SERVICE INSTRUCTION

SI-24-01
Revision 0

TITLE: Ignition System Wiring Reconfiguration

Found Aircraft Canada Inc.

FIGURE 1 SCHEMATIC – IGNITION SYSTEM

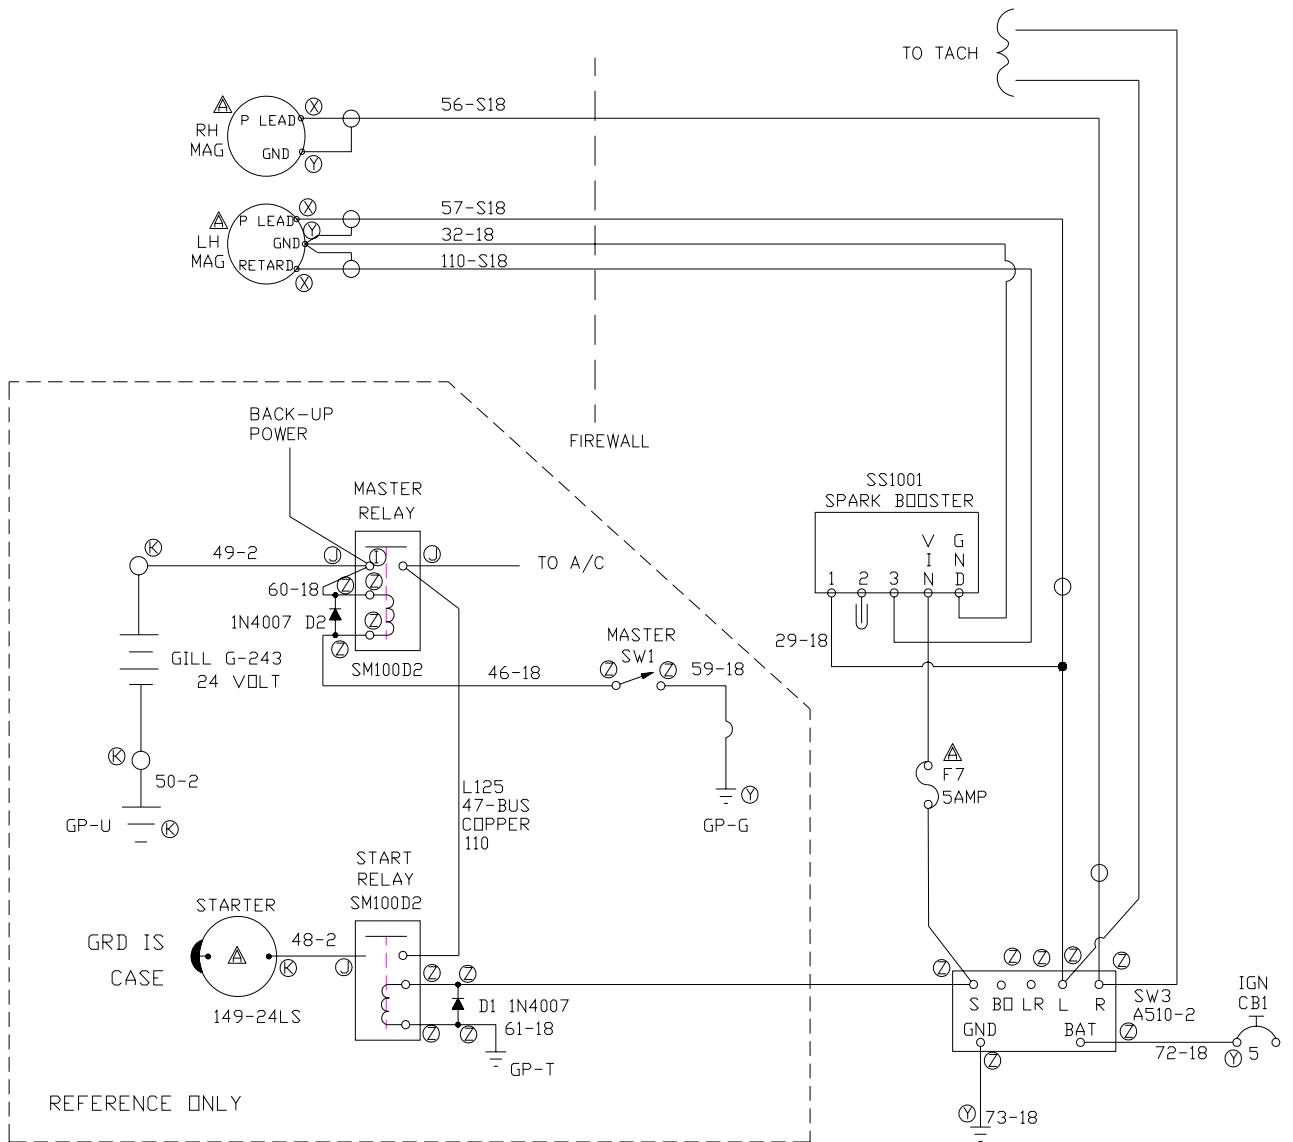
1. Gain Access to, and disconnect the ground wire (#50) from the battery in accordance with MM section 24-30-01.
2. Figure 1 illustrates the schematic for modified ignition circuit. It may be used as a reference as the following procedure is accomplished.
3. It is recommended the wiring be modified with the flight panel removed. See MM FAC2-M200 Section 31-11 Flight Instrument Panel for removal details. With reference to Figure 2, remove the ignition switch mount nut and switch plate. This will allow the switch to be removed and provide easier access to the back of the switch assembly.

FIGURE 3 PRE-EXISTING IGNITION SWITCH WIRING

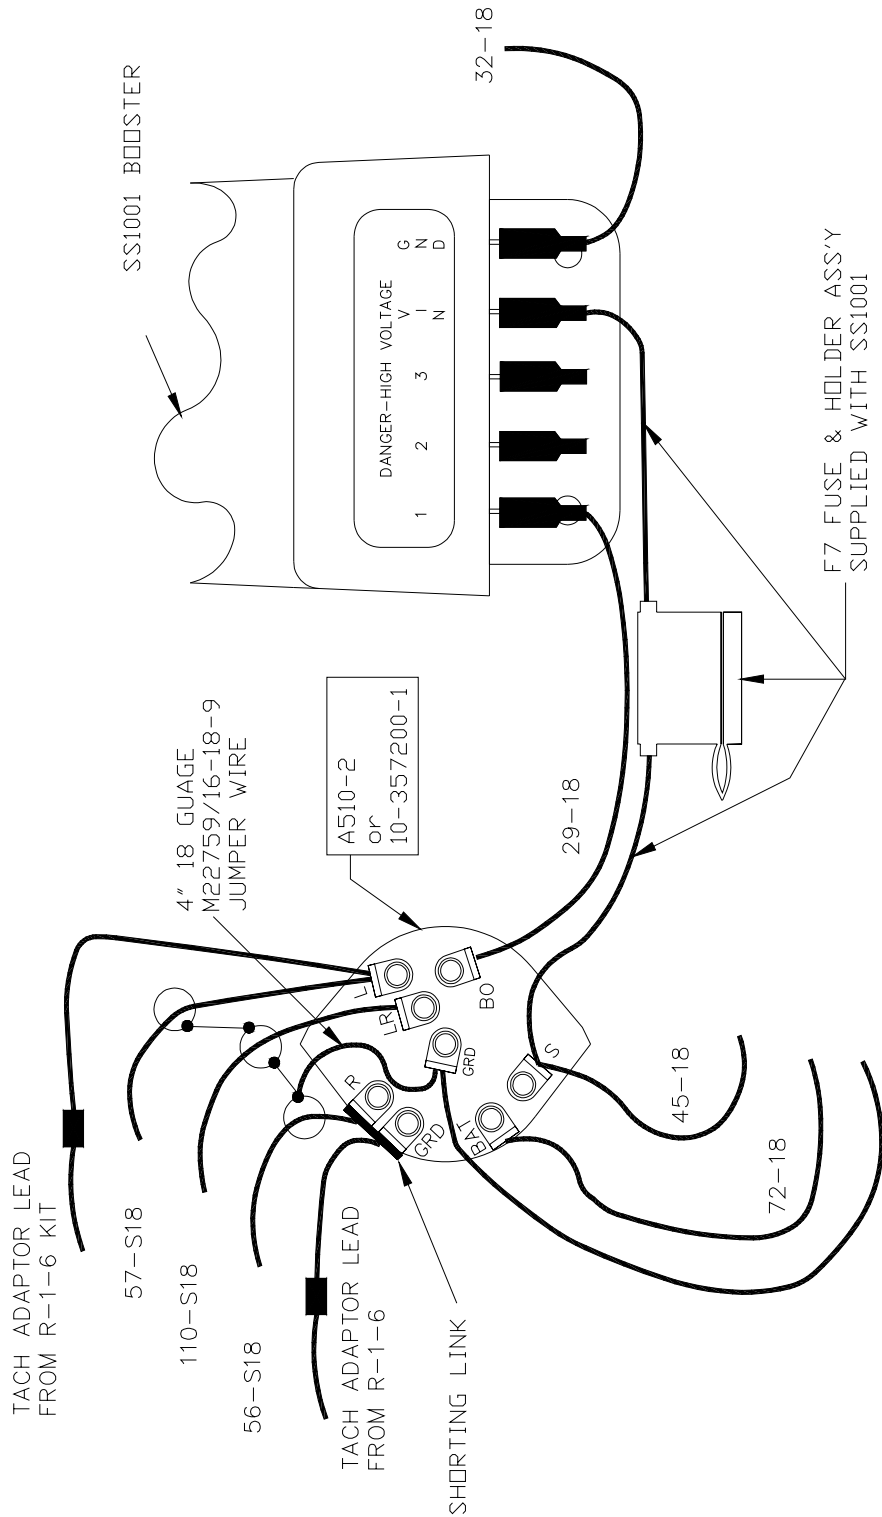
4. Figure 3 illustrates the current wiring arrangement. Note, the 10-357200-1 switch has an extra terminal, labeled “PR” and is not used.
5. The shields of wires 56, 57, 110 and the 4” jumper need to be disconnected from each other. They will remain connected at the magnetos.
6. Wire 110-S18 should be removed from terminal “LR”. The #6 ring tongue terminal should be removed. The exposed shielding may be trimmed at this time and cover with heat shrink or similar material. The spare terminal connector on Pin 3 of the

FIGURE 4 WIRE 110-S18 RELOCATION

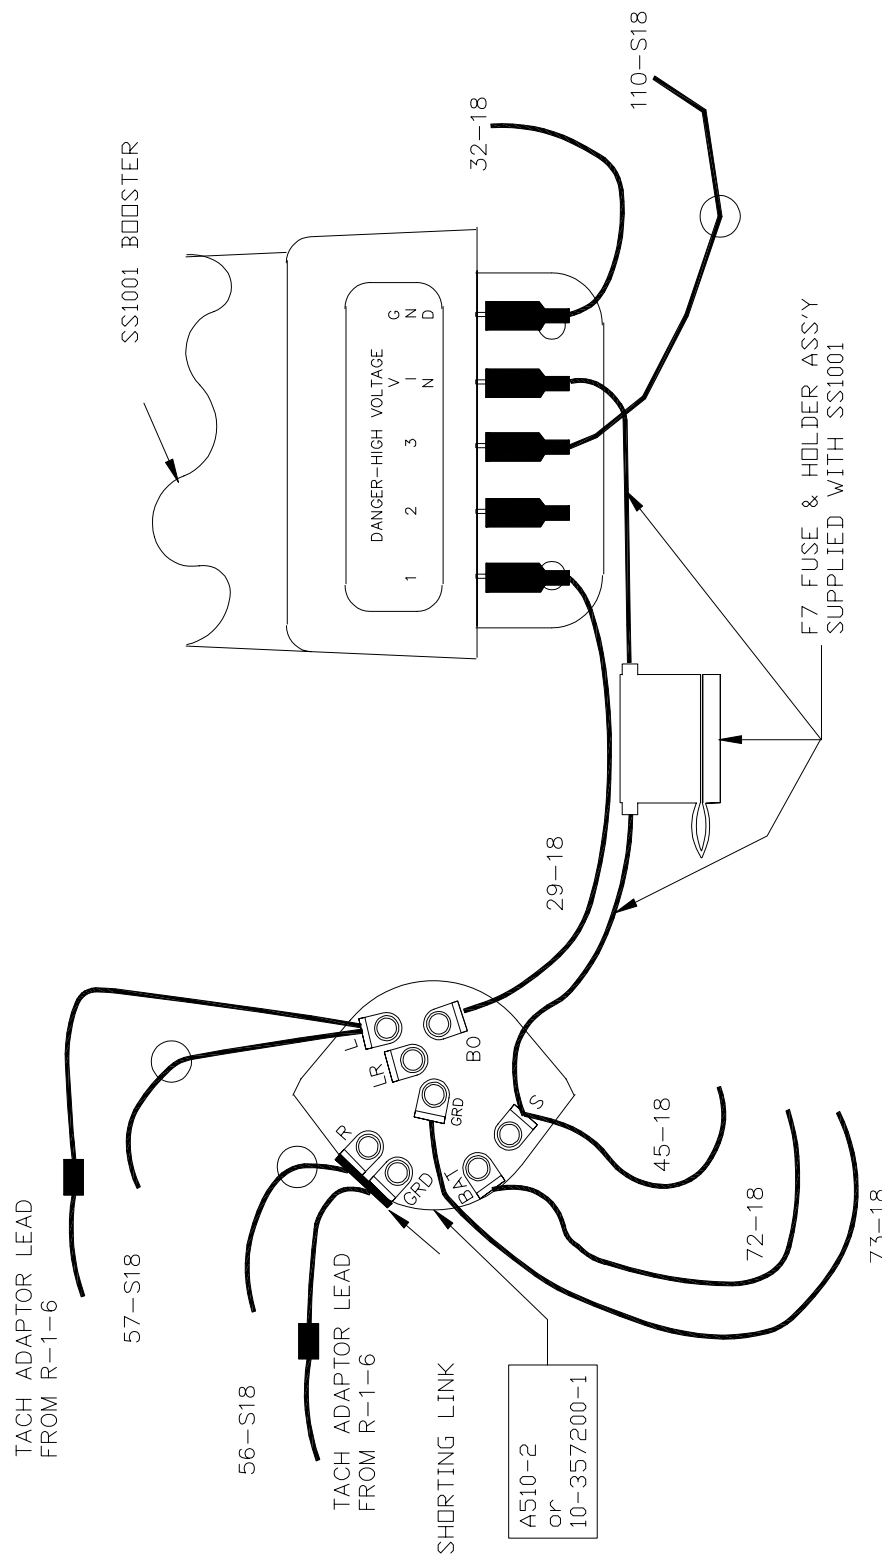
“Slick Start” maybe removed and crimped to wire 110-S18. This wire may now be attached to terminal 3 of the “Slick Start”. Reference Figure 4

FIGURE 5 POST MODIFICATION WIRING ARRANGEMENT

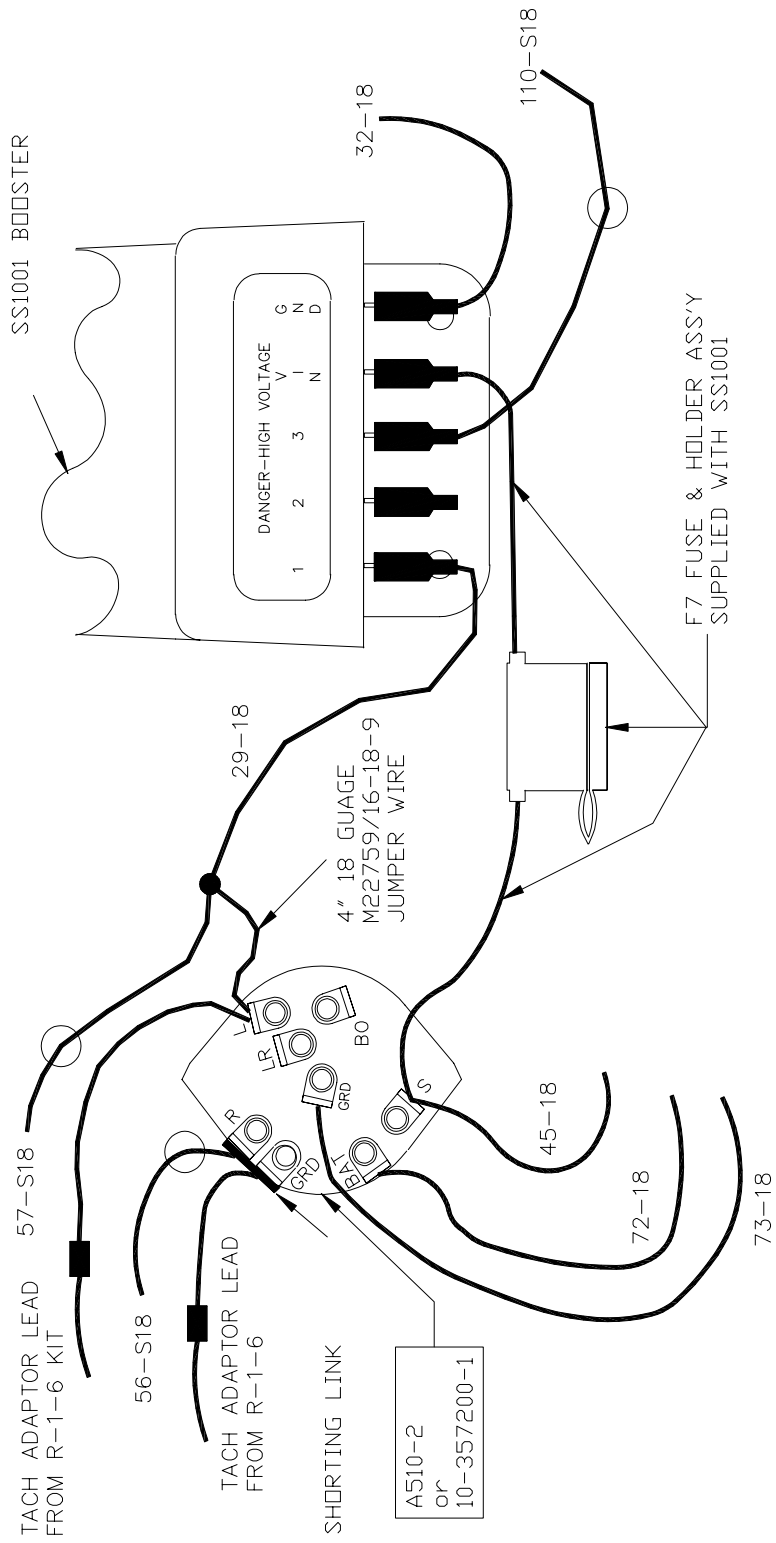
7. Next, remove wires 57-S18 and wire 29-18 from switch terminals “L” and “BO” respectively. Again, remove the #6 ring tongue terminal from the end of the wire and install a short segment of heat shrink tube to cover any exposed shielding. Wires 57 and 29 may now be joined with a short, (4”), jumper. This connection may be done with a crimp type wire nut or solder and heat shrink or any other method acceptable under AC43.13.

8. Finally, the disconnected shield of wire 56-S18 should be secured against shorting to other terminals or systems. Recommend disconnecting wire 56 from the switch terminal “R”, and installing heat shrink.
